BUCKHEAD 3RD ADDITION

Re: S/D 98-18 -- Final Plat of BUCKHEAD 3RD ADDITION

At the regular meeting of the Subdivision Committee of the Metropolitan Area Planning Commission on Thursday, March 5, 1998, the above captioned plat was considered. The action of the Committee was to approve the final plat, subject to the following:

CASE NUMBER: S/D 98-18 BUCKHEAD 3RD ADDITION

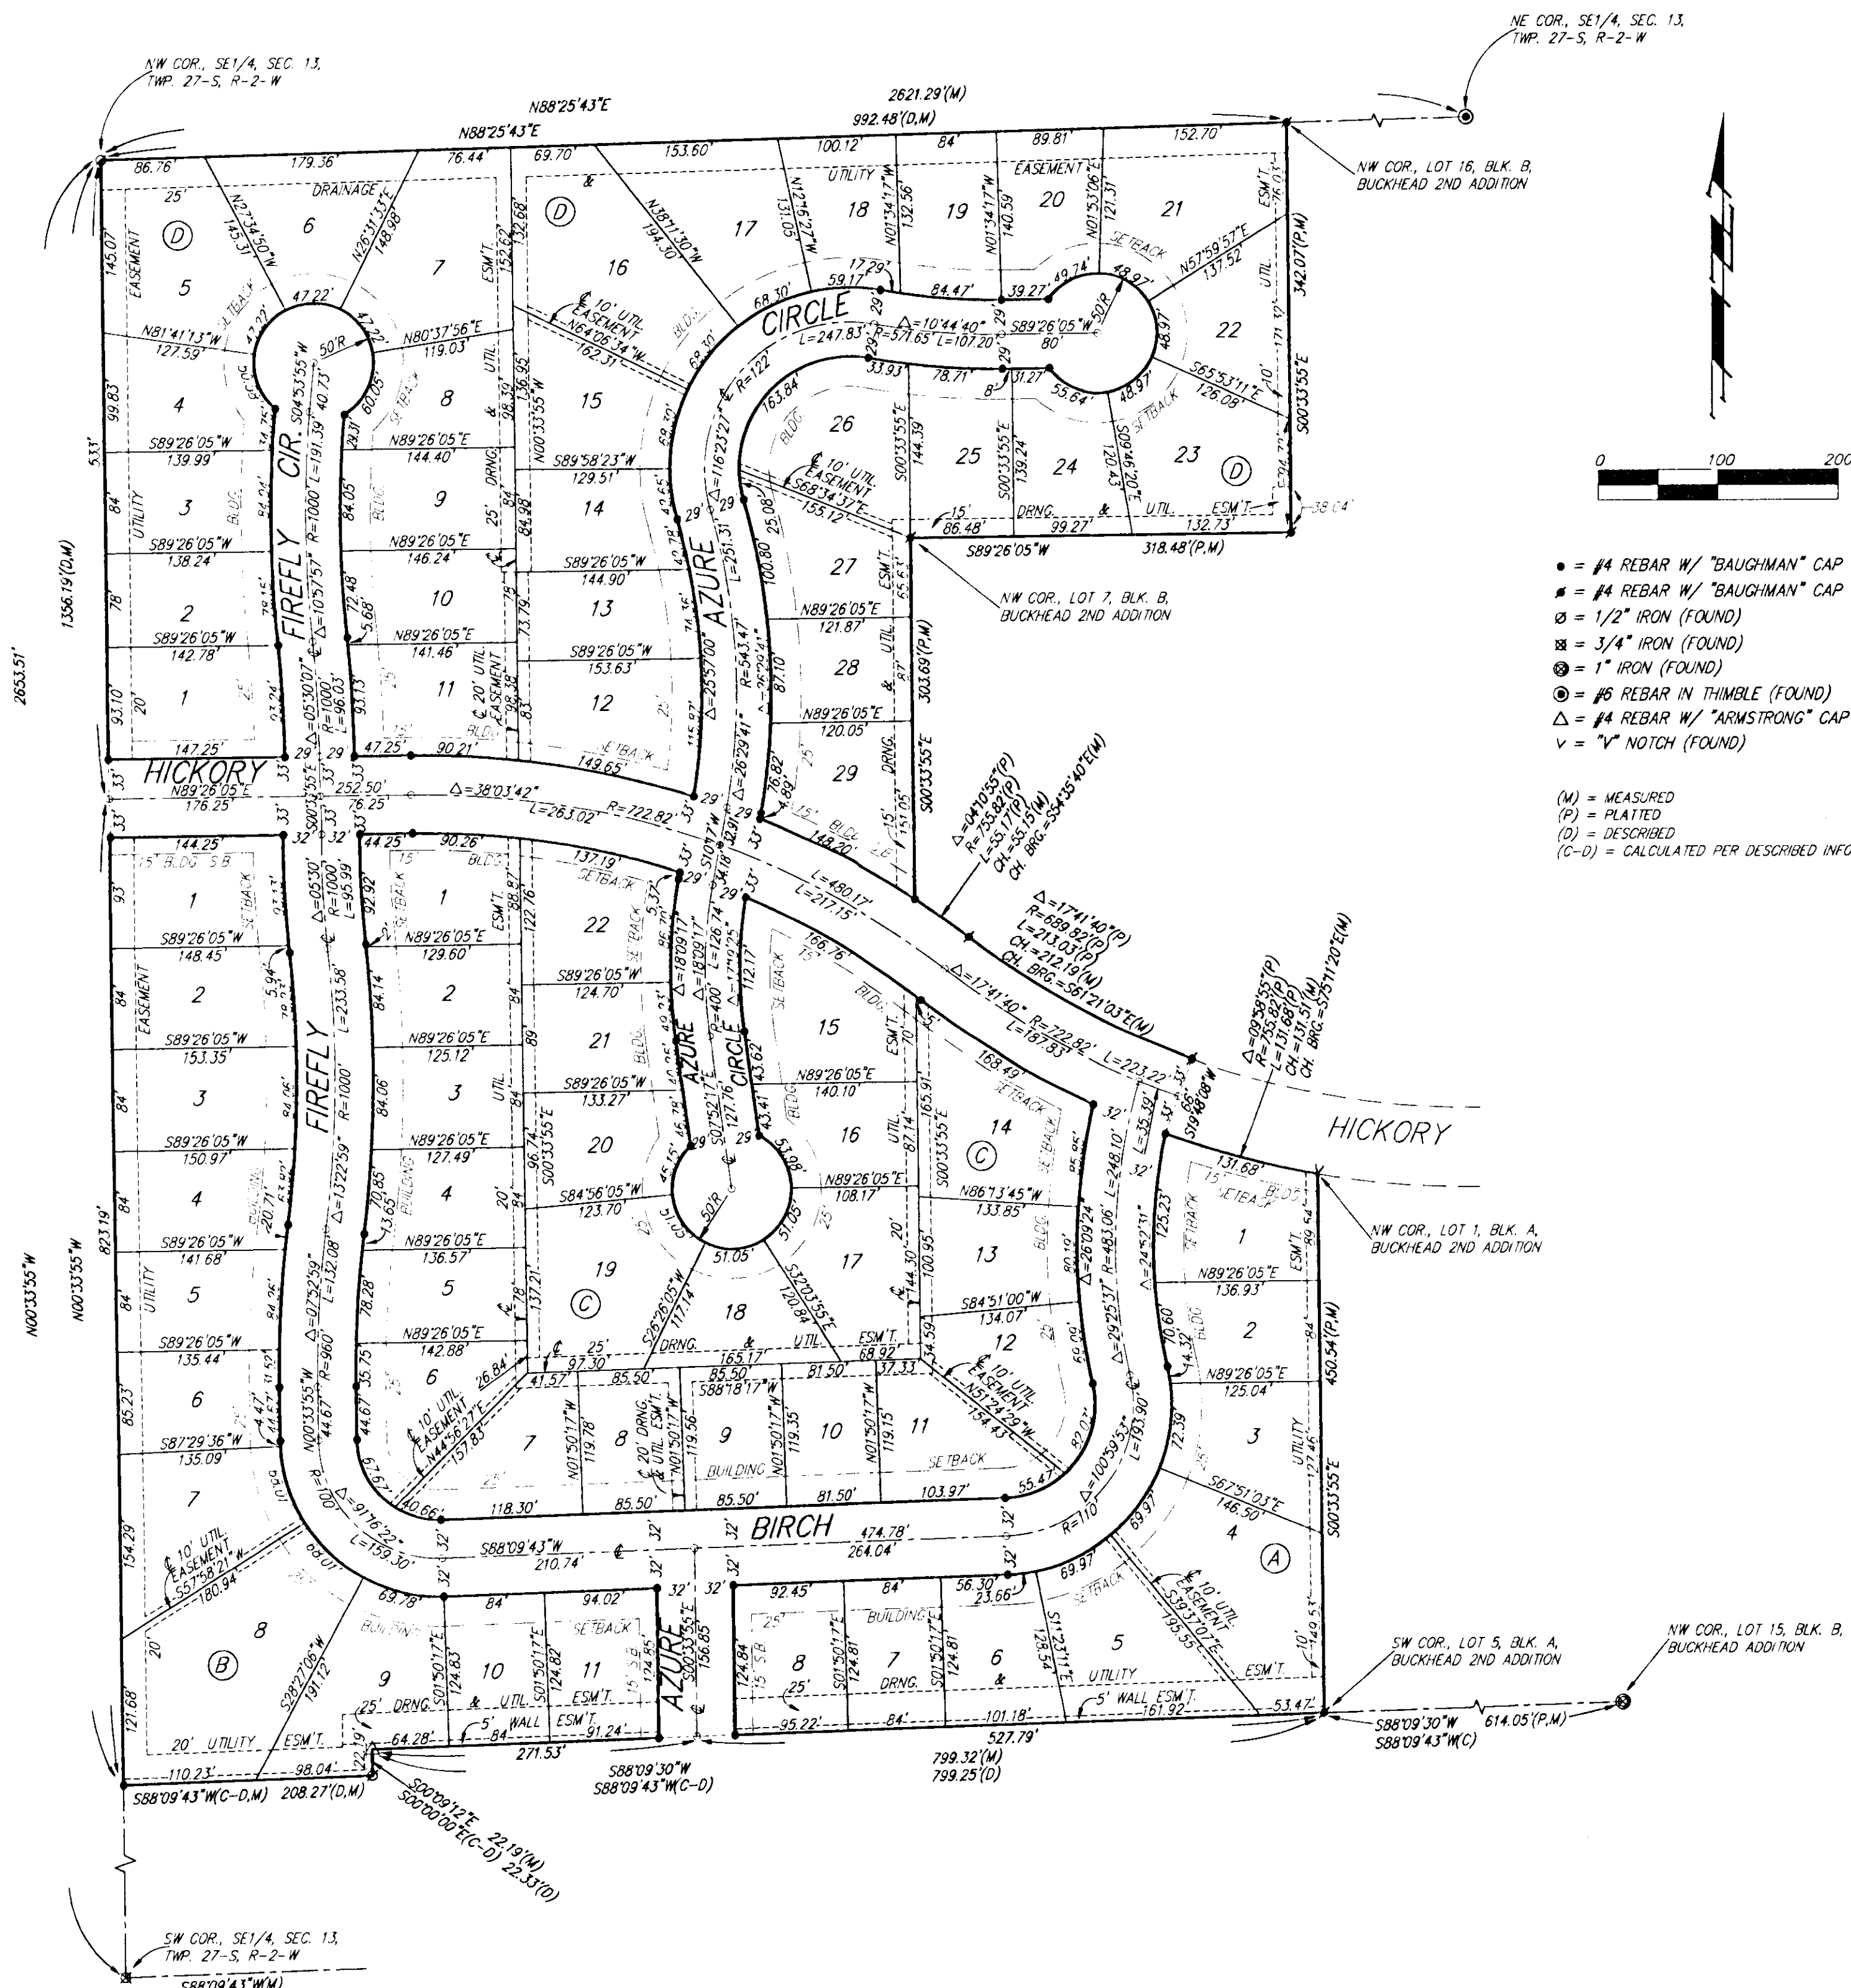
- C. City Engineering needs to comment on the status of the applicant's drainage plan. *The drainage plan is approved. Wherever storm sewer, sanitary sewer and other utilities share an easement, it is requested that the width of the easement be increased to 25 feet.*

- D. The applicant shall guarantee the paving of the proposed interior streets. This guarantee shall include the paving of Hickory to a collector status. Sidewalks shall be included in the guarantee providing for sidewalks on both sides of Hickory, and one side of the looped street Birch-Firefly.

- E. The representative from the City's Fire Department should also comment on the acceptability of the street names.
Firefly Court should be renamed Firefly Circle as it is a continuation of Firefly. Both streets named Azure Court should be renamed Azure Circle as they are extensions of Azure to the north.

- N. The representatives from the utility companies should be prepared to comment on the need for any additional utility easements to be platted on this property. **The representative from KG&E has requested additional easements.**
